**ADDENDUM NO. 4**

The following attached changes are incorporated into requirements for the Project No. 33-SBC-1008 Contract Documents by this Addendum:

KITTITAS RECLAMATION DISTRICT  
 ELLENSBURG, WASHINGTON  
 SOUTH BRANCH CANAL IMPROVEMENTS  
 ROBINSON SIPHON (MP 10.0) TO MANASTASH CHUTE (MP 13.9)  
**SOUTH BRANCH CANAL PIPELINE CONVERSION**  
 33-SBC-1008; 2024-25 REACHES  
 (MILEPOST 12.4 TO MILEPOST 13.6)

**TURNOUT 13.4 & 13.6 CONTROL STRUCTURE**  
TURNOUT PLAN & SECTION VIEWS

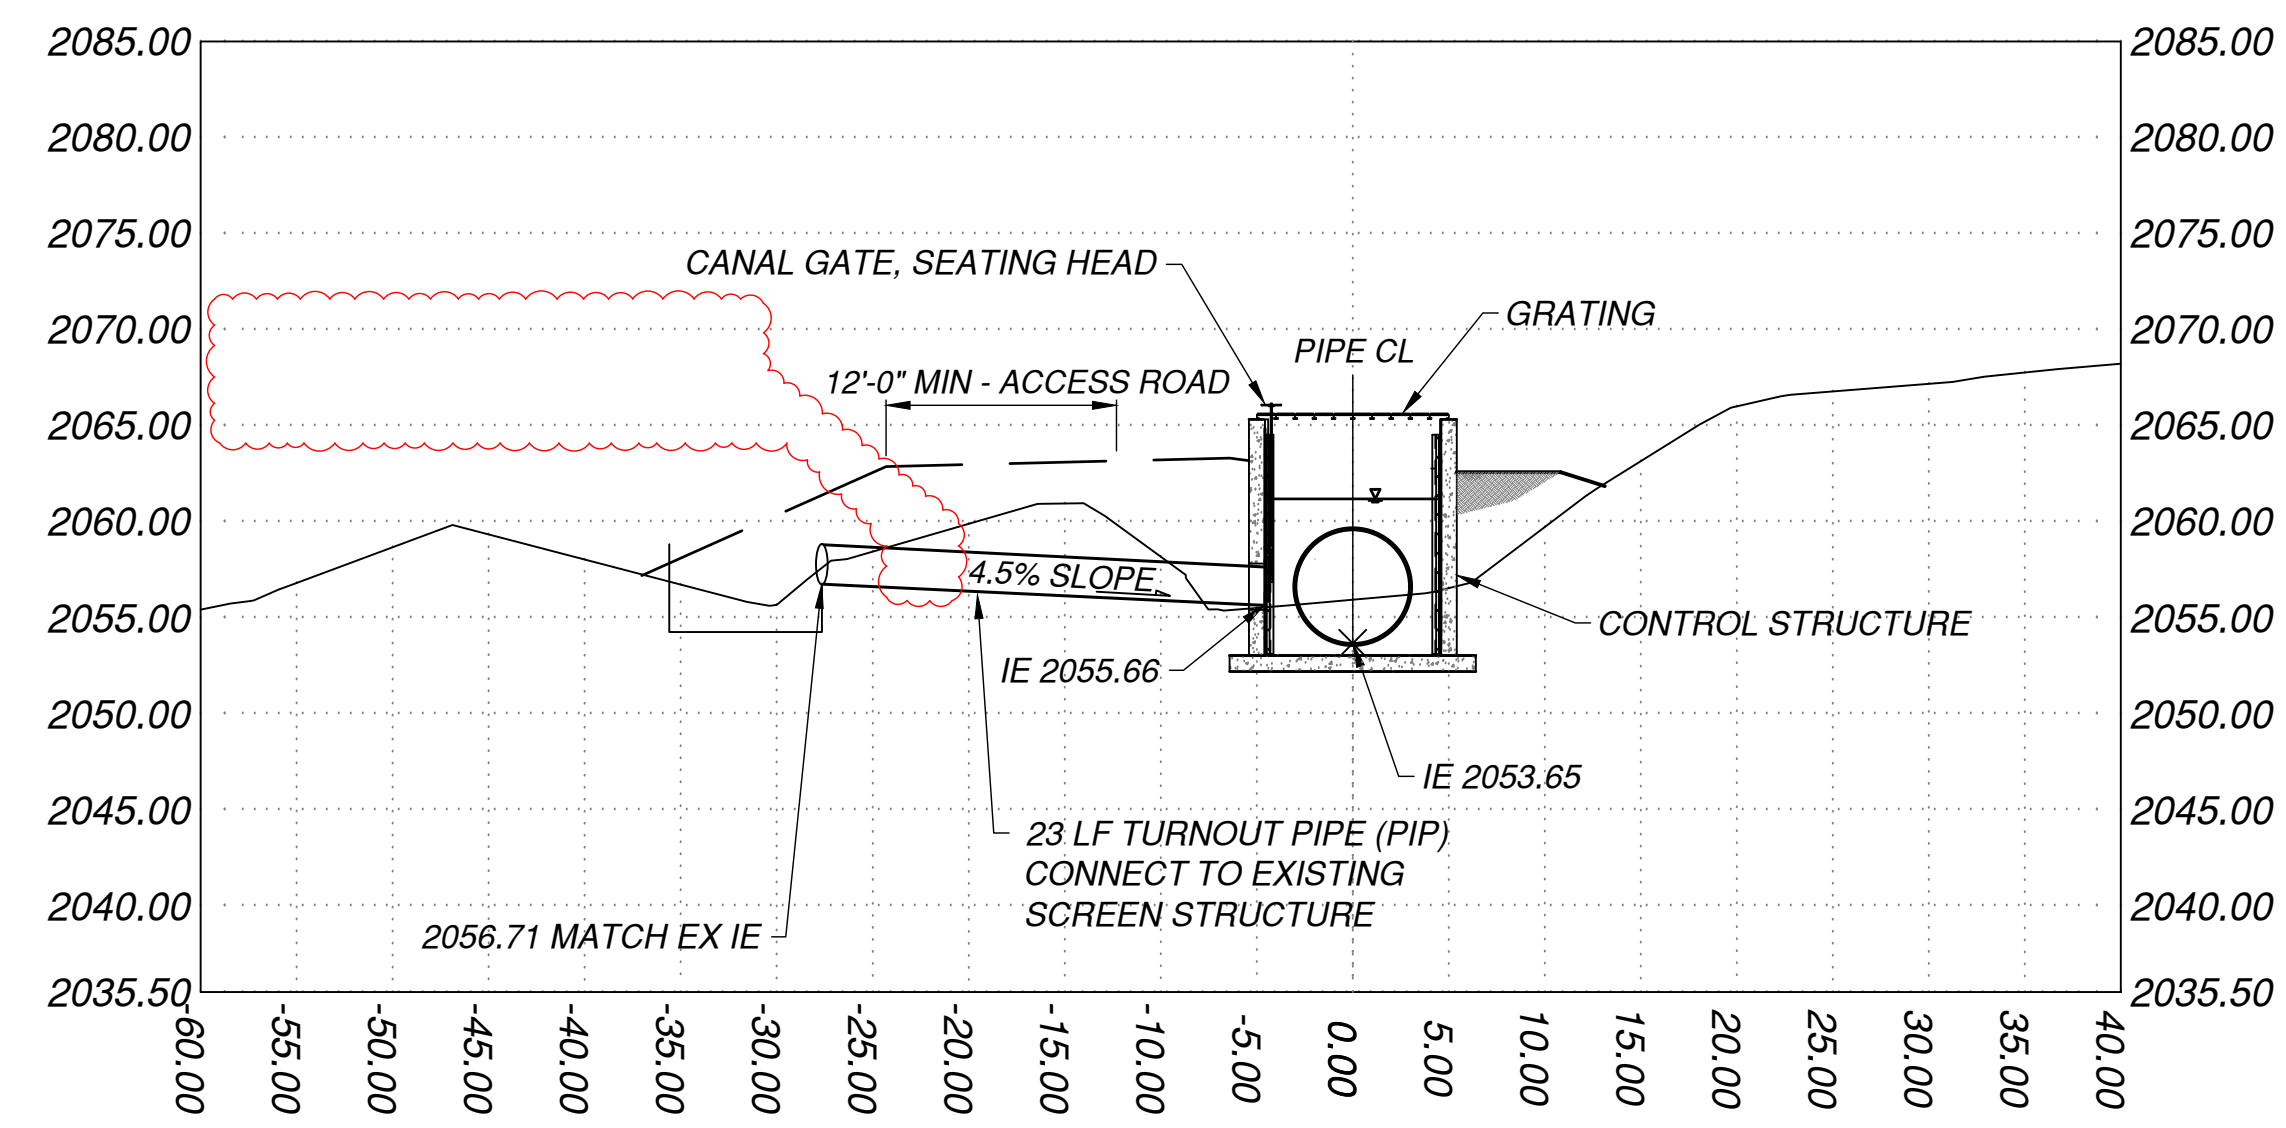
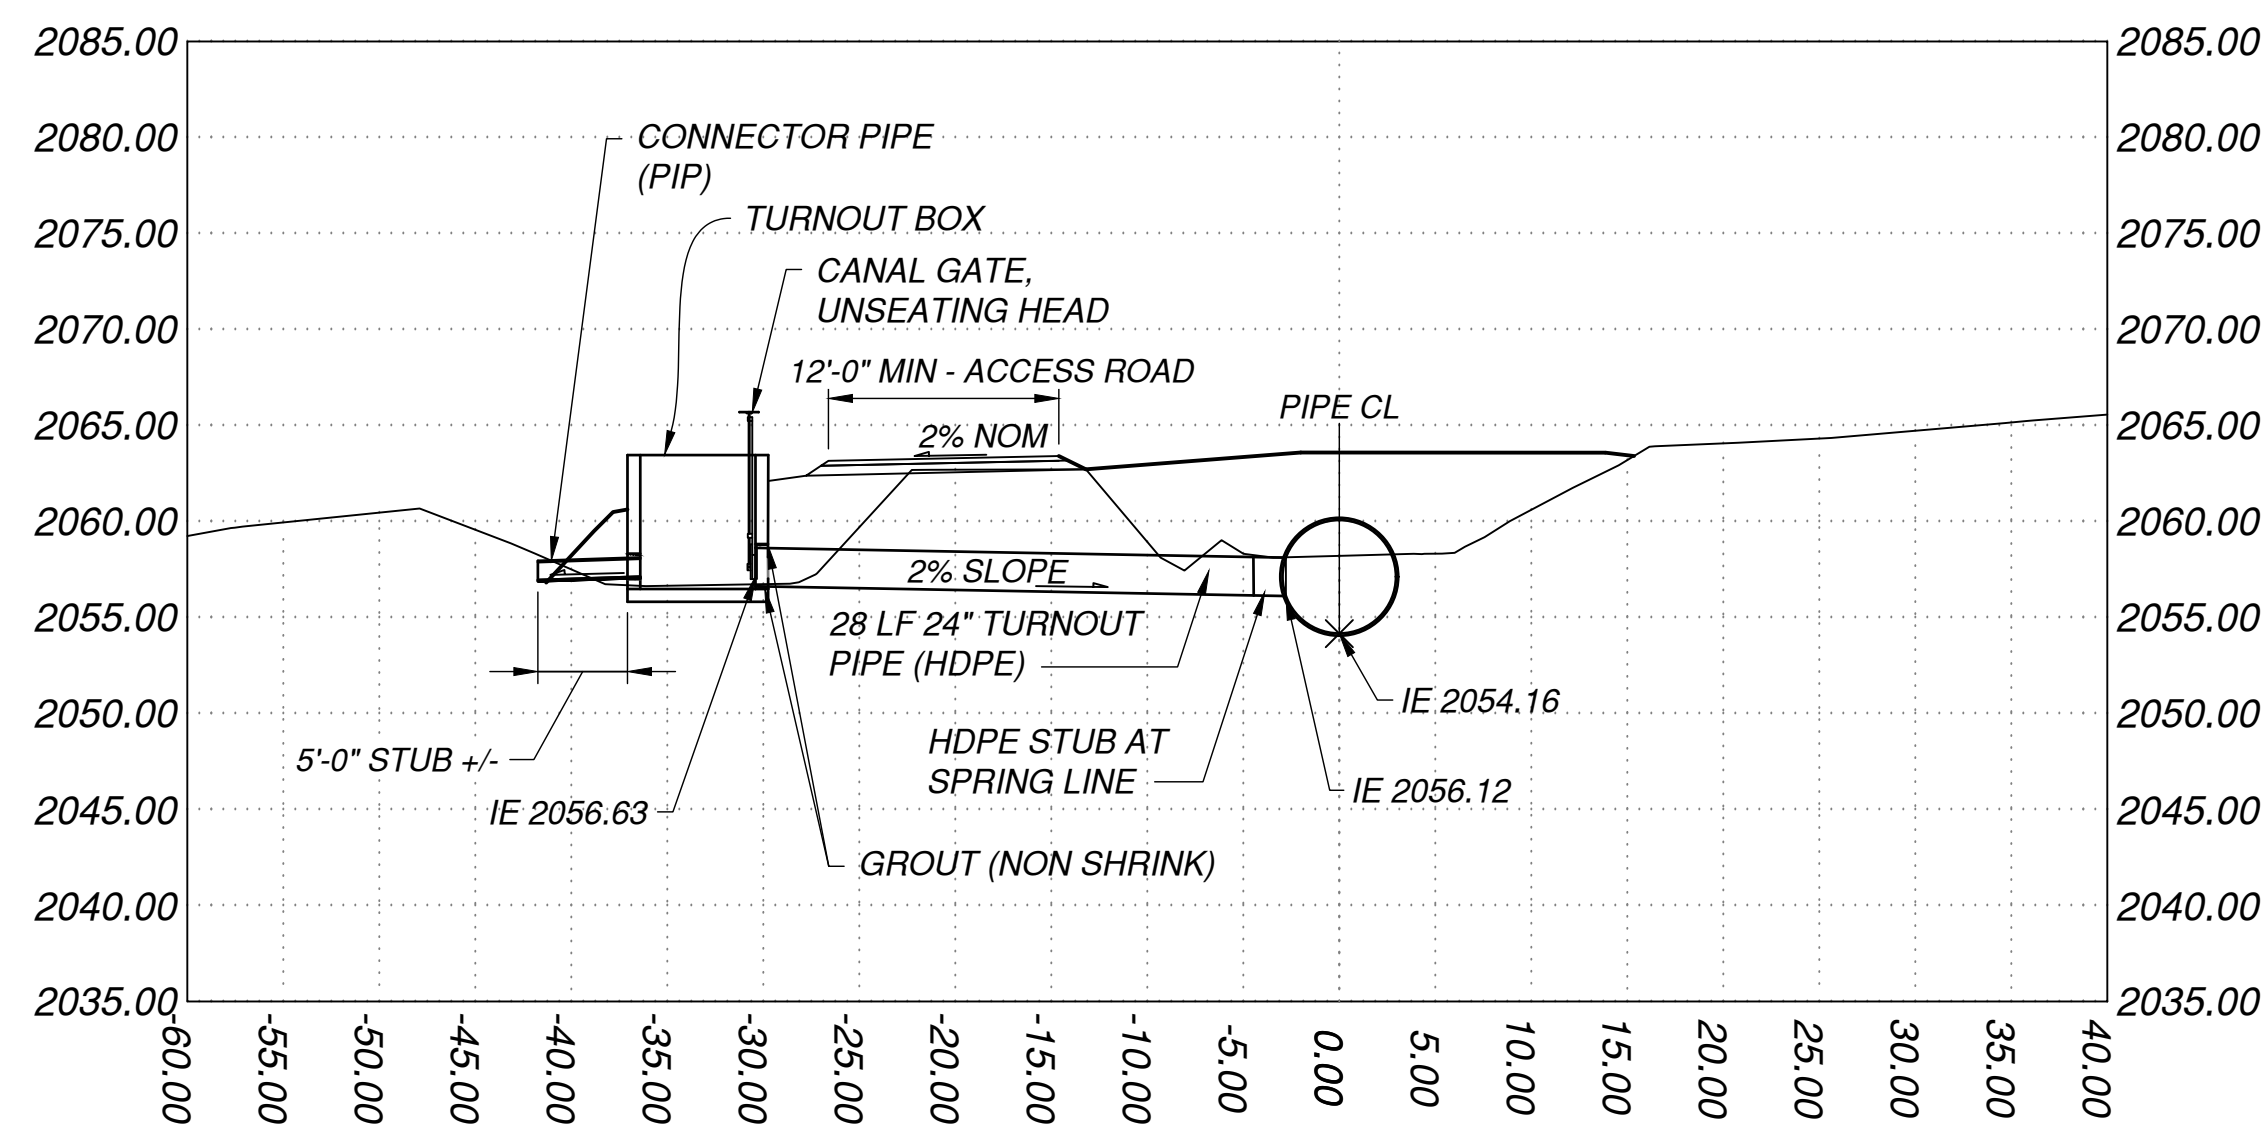
- Added Revision 1 for removal of the flow meter from SB13.6 shown in Section 198+34.38.

REV. NO.	REV. DATE	REV. DESCRIPTION
1	10-30-2024	REMOVED FLOW METER FROM XS813.6 SECT. 188-34
0	10-04-2024	ISSUED FOR BIDDING

No, see attached revised drawings C314 and C316 for removal of the flow meters associated with the SB12.8 lateral and SB13.6 screening structure. The intent of the original callouts was for the meters to be mechanical registers that do not require electrical power. However, the District has decided that existing flow monitoring further downstream will suffice and the new meters can be omitted from the bid.
